**CEDAR CREEK PARKWAY WEST 2024 IMPROVEMENTS
WAIVER FROM LAND DEVELOPMENT REQUEST 2024-703
ATTACHMENTS**

TO: PLANNING COMMISSION
FROM: GREGG ADAMS, PLANNER
SUBJECT: CEDAR CREEK PARKWAY WEST 2024 IMPROVEMENTS
WAIVER FROM LAND DEVELOPMENT REQUEST 2024-703
REQUEST FOR PLAN REVIEW

SUBJECT: South Whitehall Township
 Cedar Creek Parkway West
 2024 Improvements
 Waiver from Land Development
 Process Request #2024-703

RE: Geotechnical Engineering Review of
Provided Documents
Cedar Creek Parkway West
2024 Improvements
Waiver from Land Development 2024-703
South Whitehall Township, Lehigh County,
Pennsylvania
Hanover Project SWT24-11(009)

OVERALL SITE LOCATION PLAN

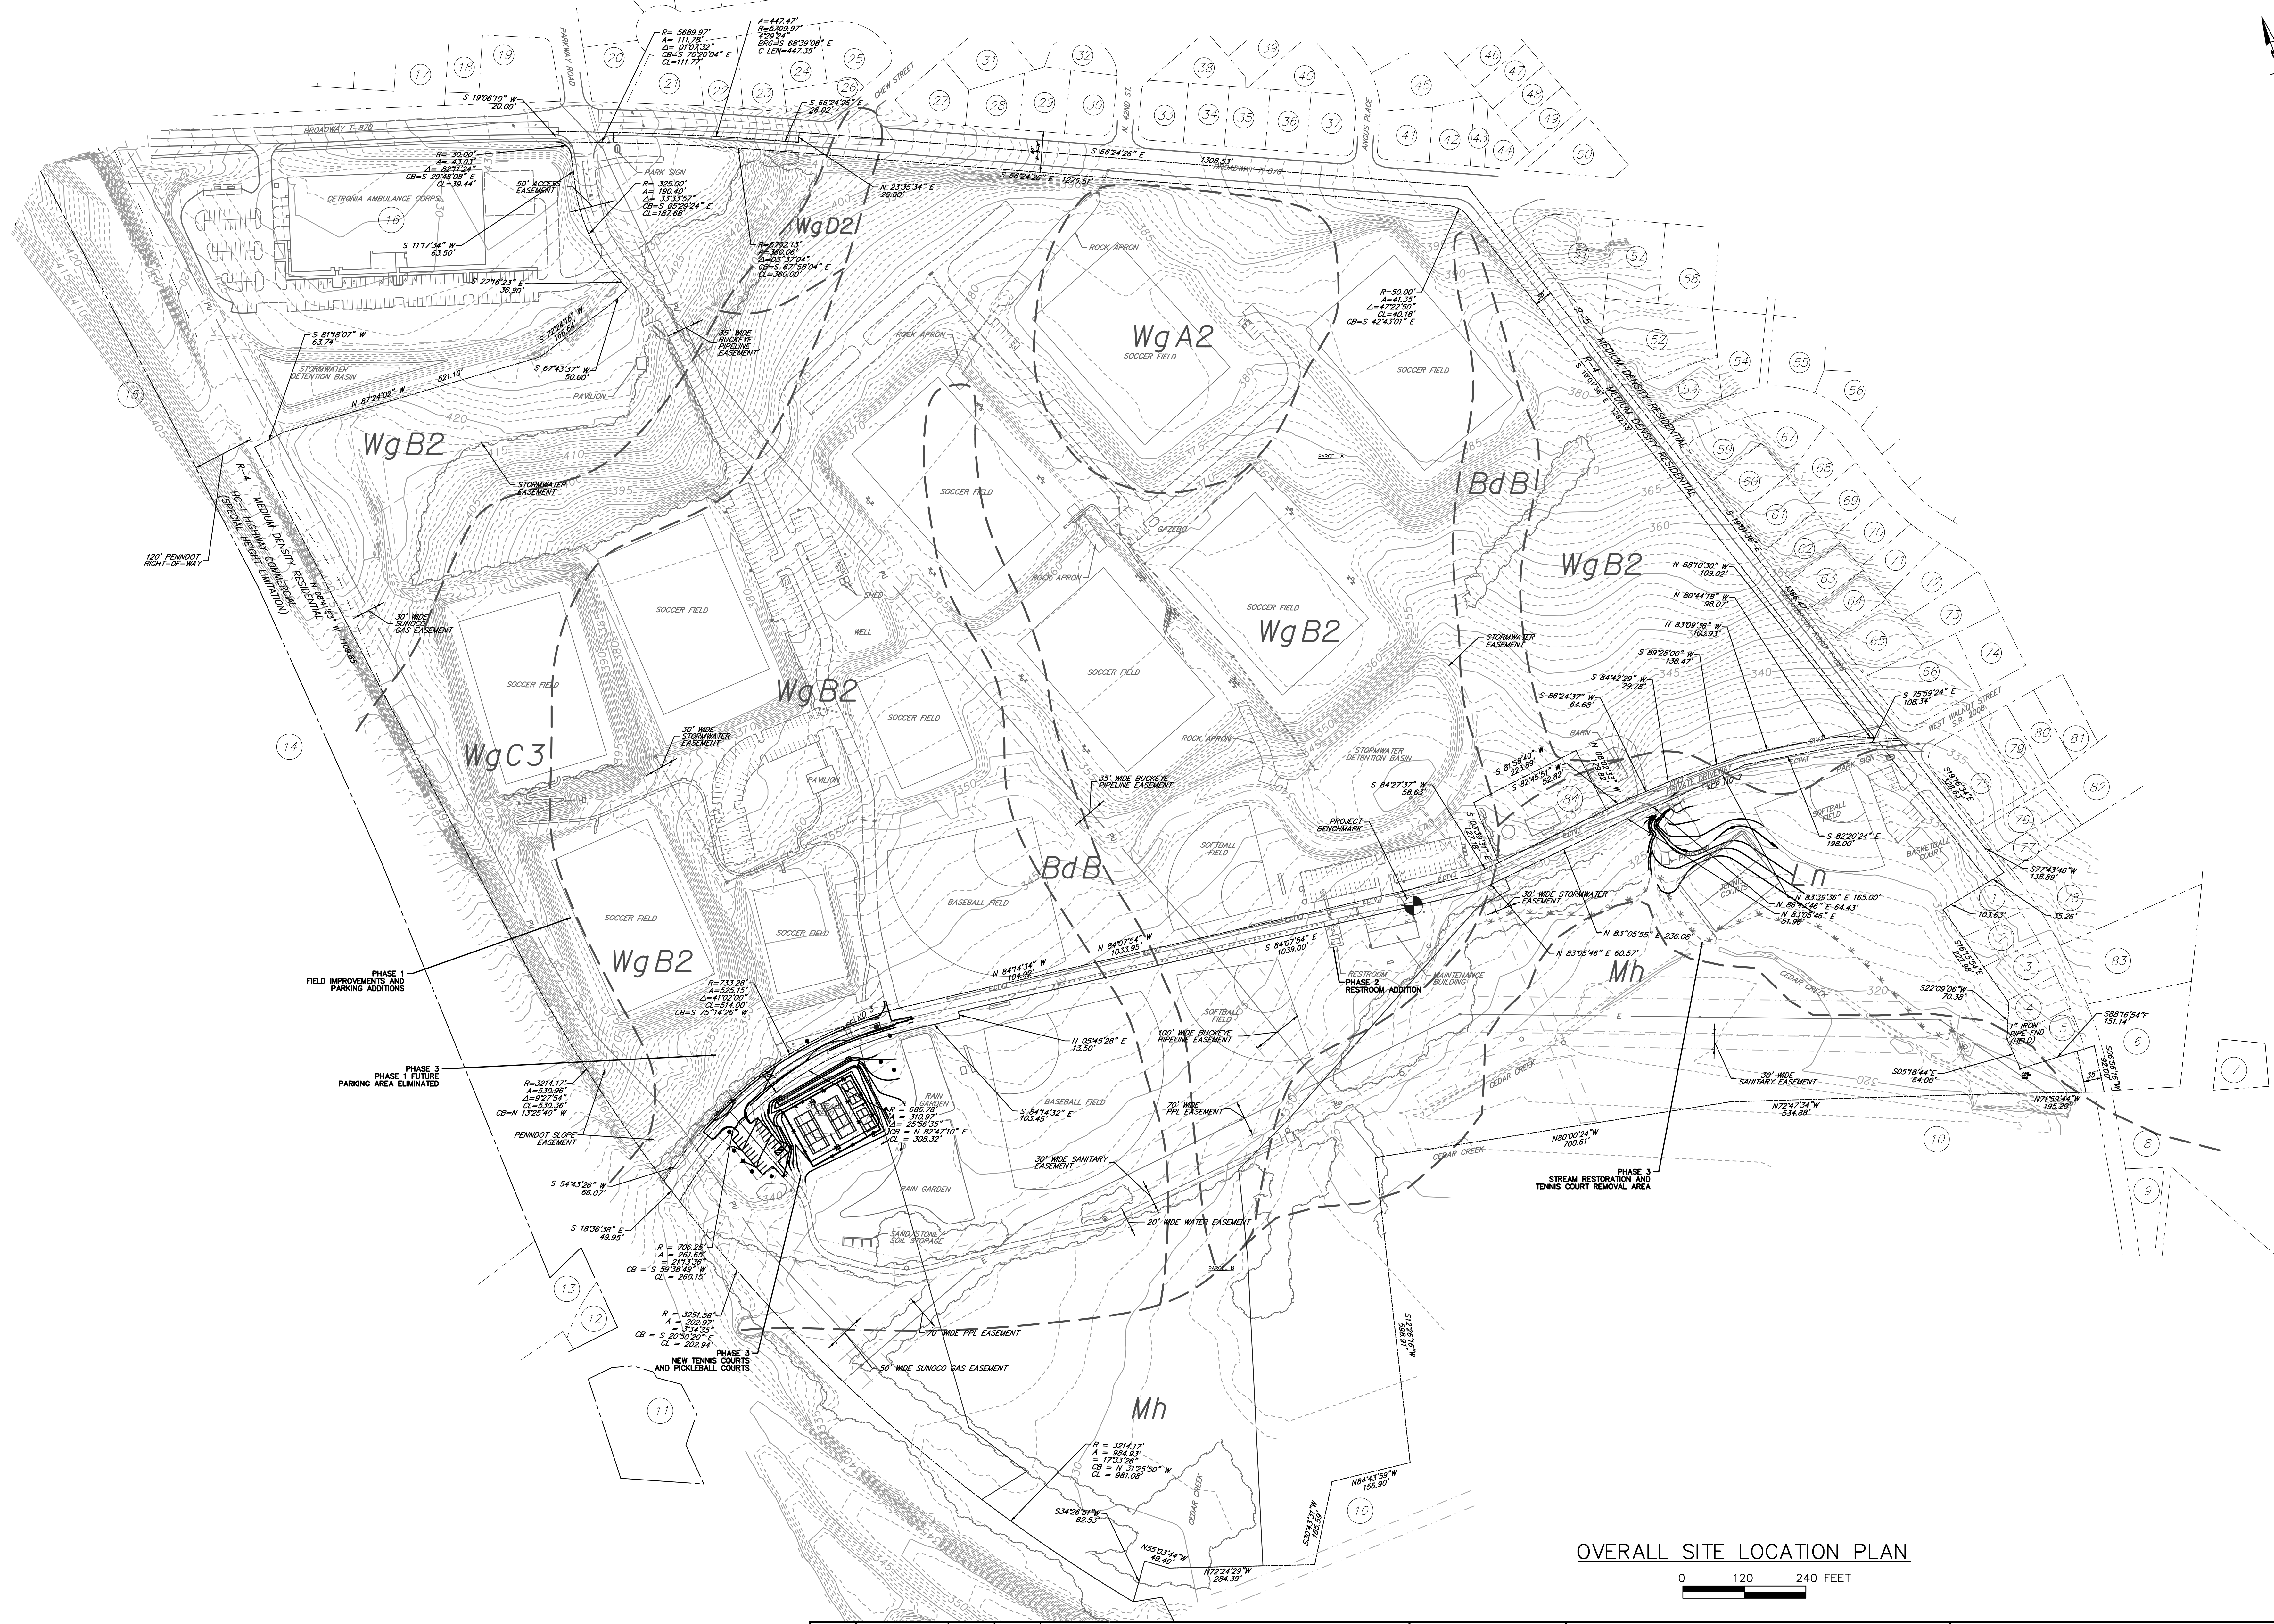
The “Existing Site Boundary Plan” (Sheet 4 of 24) and “Overall Site Location Plan” (Sheet 5 of 24) are drawn at a scale of 1” = 120’ to fully accommodate the entire site and adjoining properties on a single sheet for clarity. This is consistent with the previously approved waiver for Phase 1. We respectfully request a waiver from the plan scale requirement for these sheets. Please note that all other plan sheets are drawn at a scale of 1” = 20’, which complies with this section.

Existing and proposed contours at a vertical interval of 1-foot are provided for the entire site on the “Overall Site Location Plan” (Sheet 5 of 24); however, they do not extend a full 400 feet beyond the tracts. This is consistent with the previously approved waiver for Phase 1. One foot interval contours obtained from survey data provide a better representation of existing topography and proposed grading. Due to the size of the tracts and for clarity, it is not practical to show contours 400 feet beyond the property line without increasing the plan scale. Therefore, we respectfully request a waiver from the requirement to show contours at a vertical interval of two or five feet for the entire tract and adjacent land within 400 feet.

The location, character, and elevation of all existing features within the project tracts are clearly defined on the “Overall Site Location Plan” (Sheet 5 of 24). This information is not provided beyond the property line as the scope of work for this project is a significant distance away from adjoining properties and as such there is a lack of survey data in these locations. This is consistent with the previously approved Phase 1 Plan. Given the scope of work for the project, there is insignificant value added by displaying existing features on adjoining properties. Therefore, we respectfully request a waiver from the requirement to show the location, character, and elevation of any building within 100 feet of the tract.

The location and widths of all streets, easements, and rights-of-way for the project tracts and adjoining locations are shown where practical on the “Existing Site Boundary Plan” (Sheet 4 of 24) and “Overall Site Location Plan” (Sheet 5 of 24); however, this information is not provided for the full required 400 feet beyond the tracts. This is consistent with the previously approved waiver for Phase 1. Due to the size of the tracts and for clarity, it is not practical to show the location and widths of all streets, easements, and rights-of-way for the entire tract for the full required 400 feet beyond the tracts without increasing the scale. Therefore, we respectfully request a waiver from this requirement.

- a. SALDO §312-12(b)(1) – Plan scale (plans are drawn at 1” – 120’) – we have no engineering objection to this request;
 - b. SALDO §312-12(b)(15) – Existing and proposed contours within 400 feet of the site – based on the limits of the information provided we have no engineering objection to this request;

- c. SALDO §312-12(b)(20) – Buildings within 100 feet of the tract – we have no engineering objection to this request;
 - d. SALDO §312-12(b)(21) – Show the location and widths of all sidewalk, trails, driveways, streets, easements, and right-of-way platted or existing within the subdivision and within 400 feet of any part of the tract – we have no engineering objection to this request;

PLAN - TENNIS/PICKLEBALL COURTS

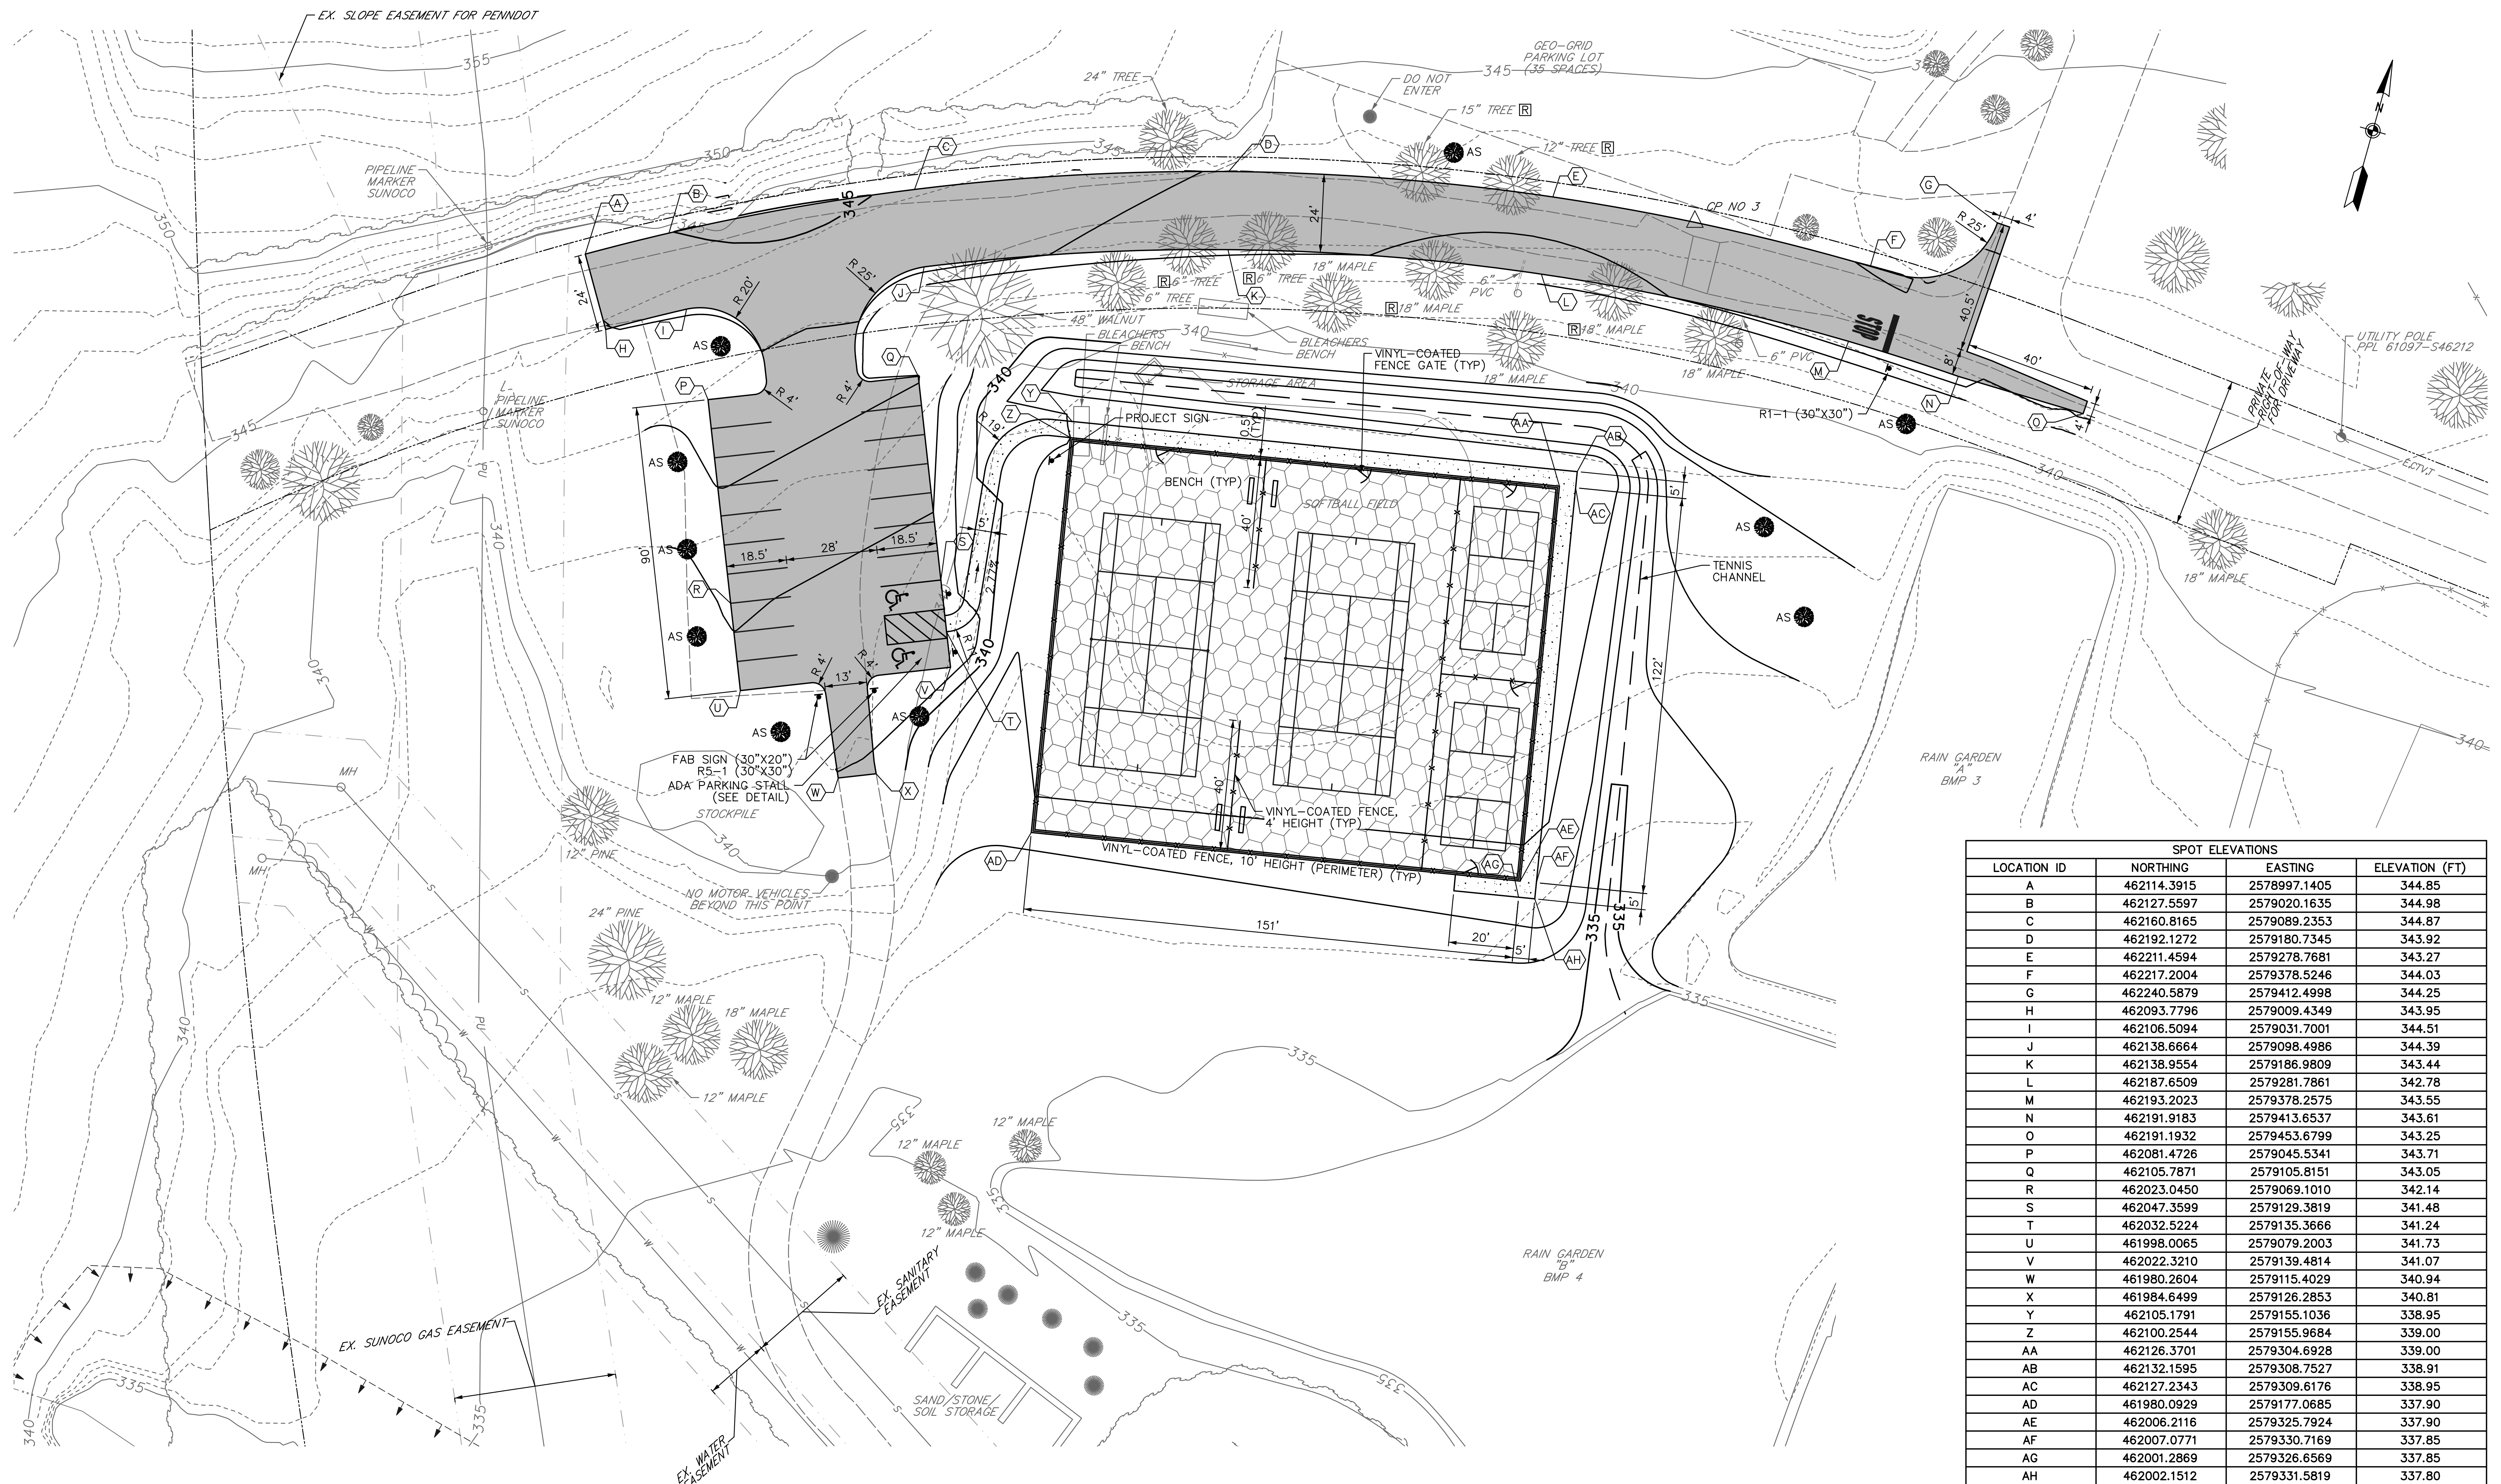
4. Provide appropriate design calculations (including a drainage patterns map – as applicable) for the proposed swale/channel(s) around the tennis/pickleball courts and for the channel restoration area, SALDO §312-12(b)(38);
